LOWER SNAKE RIVER LITTLE GOOSE AND LOWER GRANITE LOCKS AND DAMS

**Adult Fishway Systems
Emergency Auxiliary Water Supply
Phase II – Technical Report**

Final Report

U.S. ARMY ENGINEER DISTRICT WALLA WALLA, WASHINGTON	
LITTLE GOOSE LOCK AND DAM	
EMERGENCY AUXILIARY WATER SUPPLY	
SITE PLAN	
SCALE AS SHOWN IN V. NO.	
PLATE 11

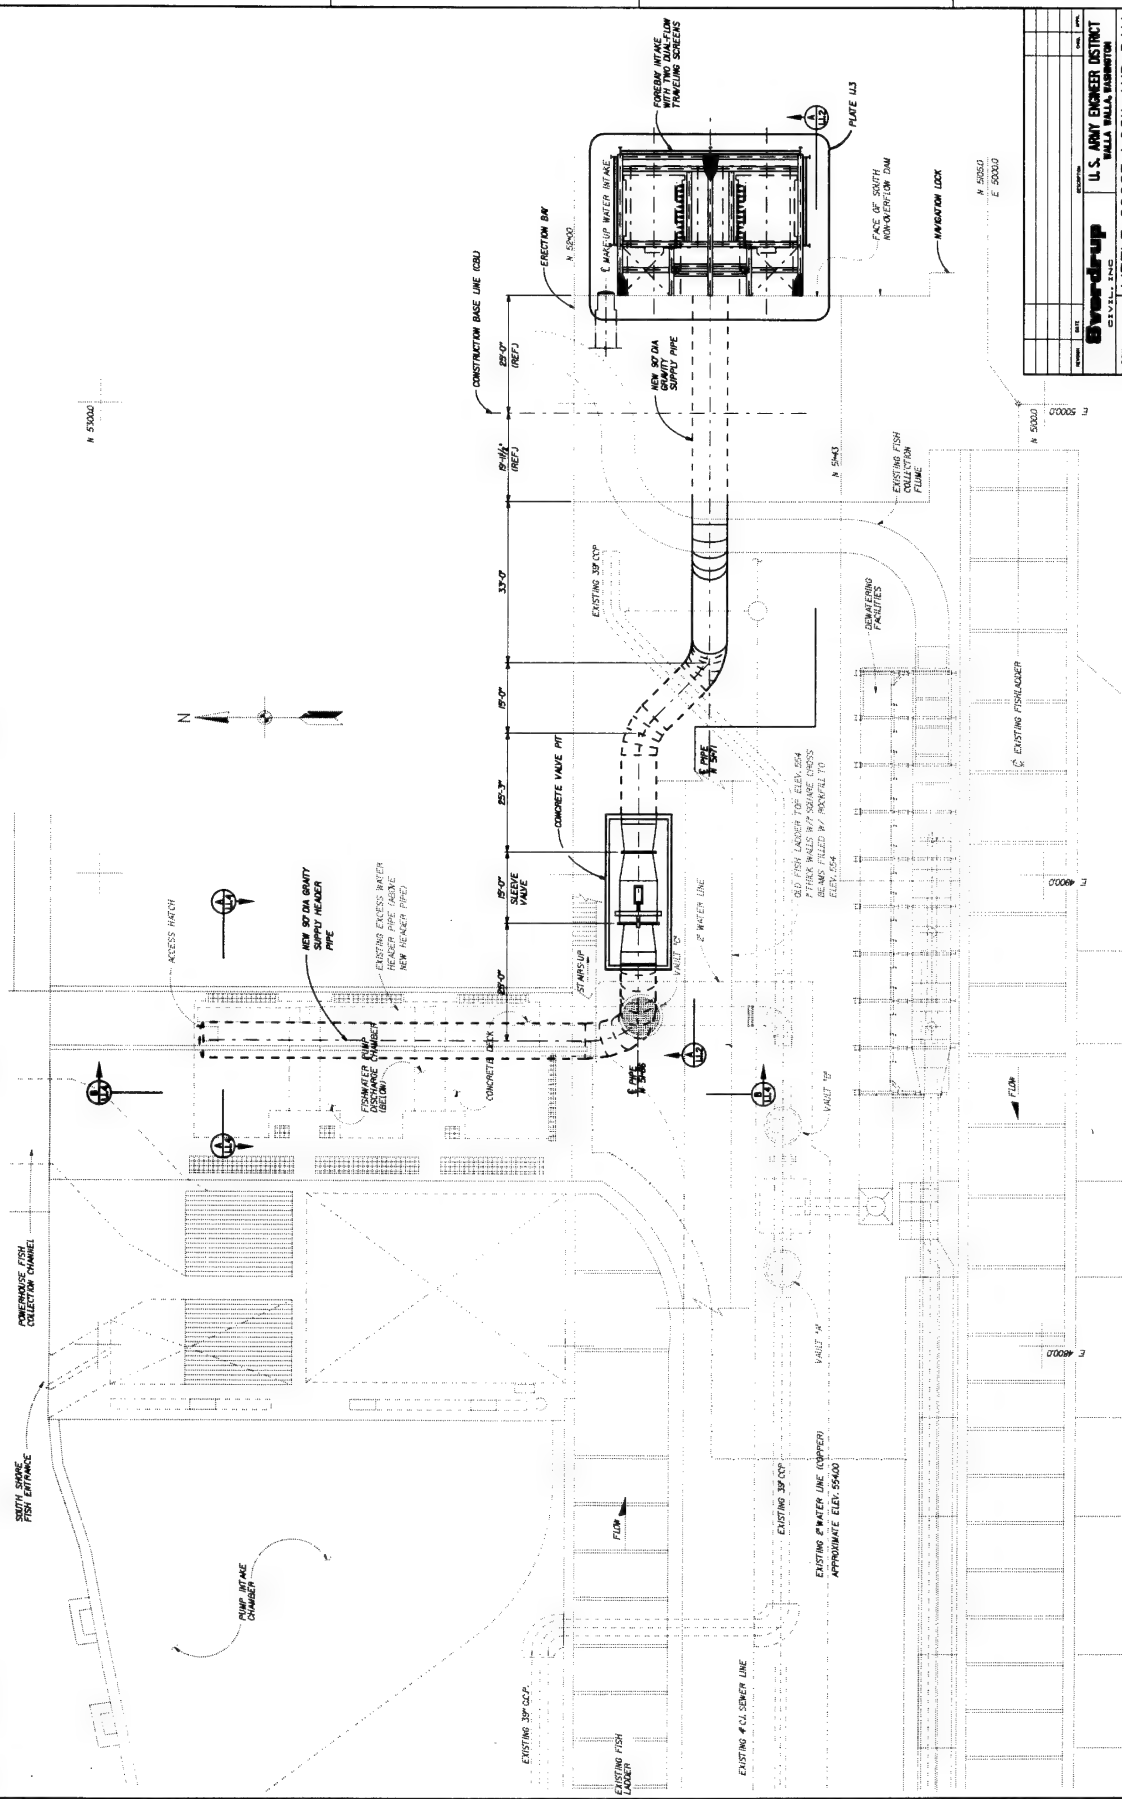
Item No.	Drawing Sheet Spec. Paragraph	COMMENTS	NA	MRV
9	Plate 1.1.1	Will butterfly valve be able to regulate properly given the number of bends in the line both upstream and downstream of the valve?	A – For butterfly valves, optimum location is 5 pipe diameters downstream of an elbow. This can be reduced if the orientation of the valve is adjusted to reflect the plane of the upstream elbow. There are about 5 pipe diameters upstream of the valve. No restrictions on downstream bends, etc. are known.	MRV
10	Plate 1.1.2	Pipe ring stiffeners may be needed. This should be reviewed.	C	MRV
11	Plate 1.1.2	Additional pipe support(s) may be needed in the more or less vertical section of 90-inch diameter pipe.	NA	MRV

5	Plate 1.1.2	Installation of two combination air/vacuum valves appears to be sufficient for the length of the supply pipe. However, a waterhammer analysis should be done (if this option is pursued beyond the Phase II level) to verify system pressures during critical operating scenarios, such as closing or opening the flow control valve (72-inch sleeve valve) and the sluice gate.	A – Agree	NA	MR

PLATE 11.2

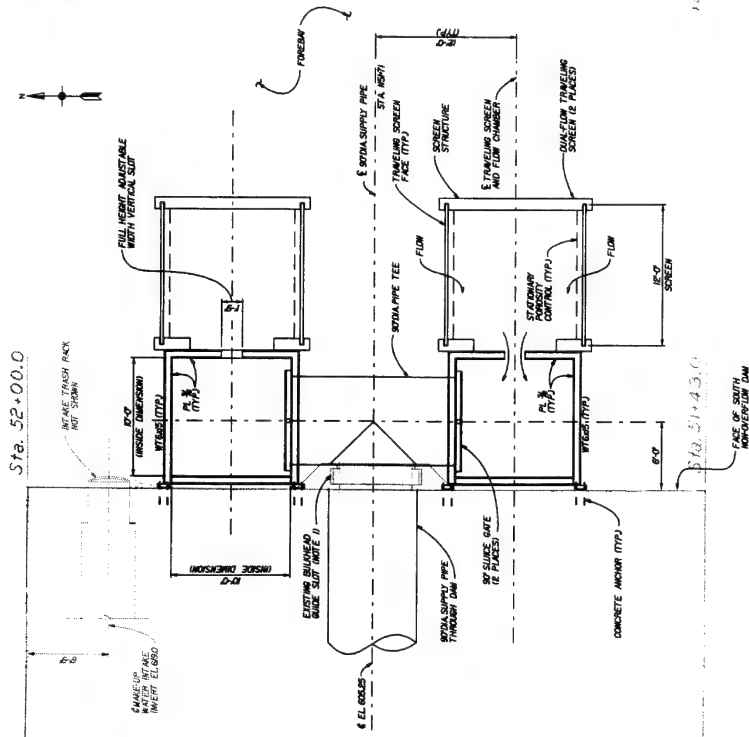
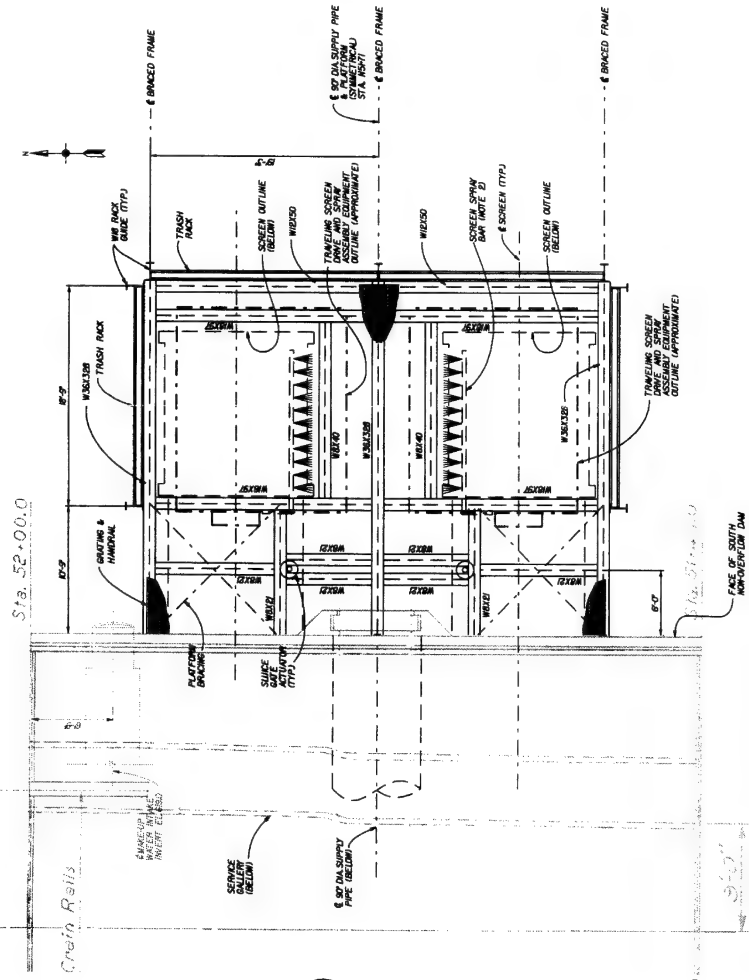
3.	Plate 1.1.3	What are the existing guides where the new gravity pipe is penetrating the dam used for? The drawing says it's an existing bulkhead guide. And note 1. Says to remove the guide where the pipe penetration is. Is the guide something that is going to be installed prior to the pipe and then removed? Or is it and existing guide that may be needed again in the future and will not be available?	A - The guides are no longer used. They were part of the temporary fish ladder which was used during construction of the dam.

30	Plate 1.1.3	Will there be any annunciation for screen plugging? There are no details on the screen guides, drive system, debris removal system, screen material, or screen panel mounting arrangement. The DDR does not contain any catalog information on this system.	A - The lack of annunciation was mentioned in the ITR, also. The text will be revised to note that. A copy of the vendor information on the screen will be added to the DDR in the cost estimates (typical costs).	
31	Plate 1.1.3	Explain the provisions for removing and/or cleaning the trashracks.	A - It was envisioned that the racks would be cleaned in the same manner that the AWS intake racks are cleaned. According to the project, they are lifted clear of the guides and "schwooshed" off in the water with a crane. Residual material is picked clean by hand. This will be noted in the text.

PLATE 11.3

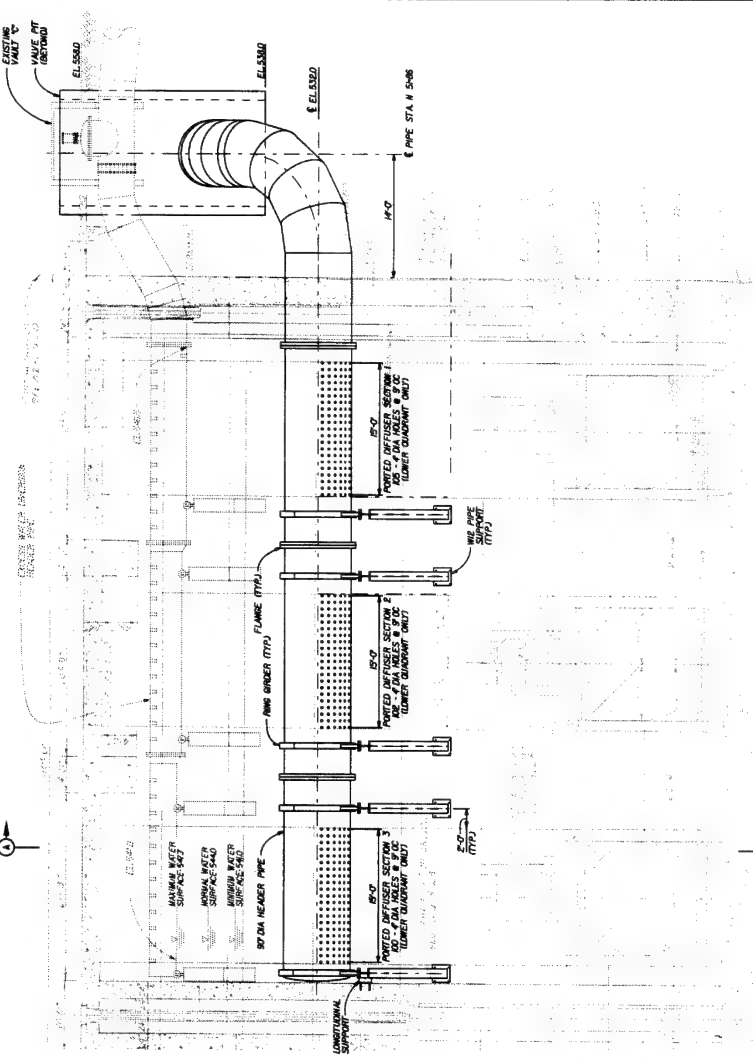
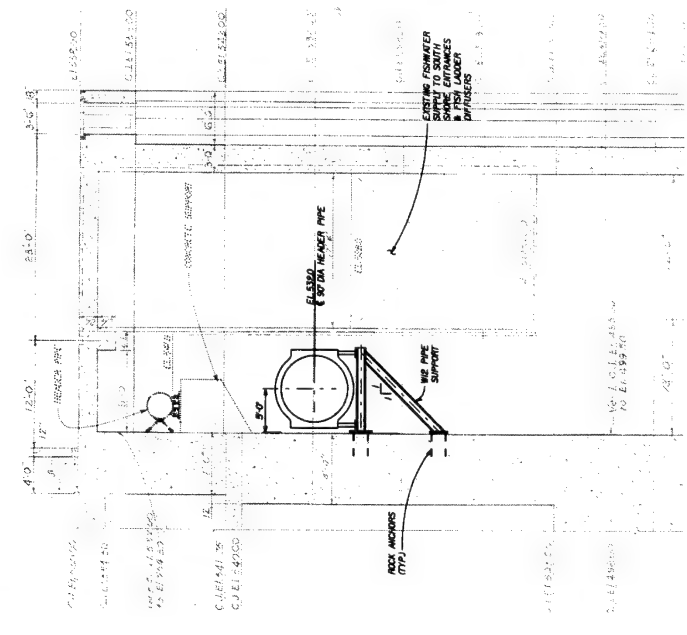
17	Plate 1.2.2	In report section 4.5.3.4.b, first paragraph, installation of each pump structure as a single piece is described. Section A of Plate 1.2.2 should depict more specific structural continuity, between the deck level support and the lower structure, if the structure is to be transported and installed as a unit.	A - I think that your Comment No. 7 is valid. The text will be revised to indicate that construction installation would be accomplished with components bolted together at the site.	C	KBF
18	Plate 1.2.2	Section A: Attaching to the midspan of the crane rail beam may apply forces in excess of available capacity. A more substantial structure may be necessary to span across the entire opening without using the crane rail beam for support.	A - I agree. The crane beam may have reserve capacity, however, it would be prudent to span the 42' rather than attach to the beam. We will review this in the design.	C	KBF

4.	Plate 1.2.2	1. It looks like it may be difficult to get the draft tube bulkheads in the slots behind the pumps. Is their adequate clearance? 2. How does the steel plug in the bulkhead slot get removed if a bulkhead needs to be installed? 3. How is the steel structure protected from corrosion?	A - The design is intended to provide a clear path for bulkheads, roughly defined by the width of the slot opening in the concrete roof of the draft tube discharge. This should be possible with the configuration shown. Note that the flap gate which appears to protrude into this space would not protrude during the installation/removal of the bulkheads. The same mechanism/system that is used to retrieve the bulkheads (lifting beam on the crane and lifting eyes on the equipment) would be used. Should work the same way. Corrosion protection could be the COE's heavy duty paint system or a metalized coating system. Impressed current systems don't seem to be very successful over the long term.
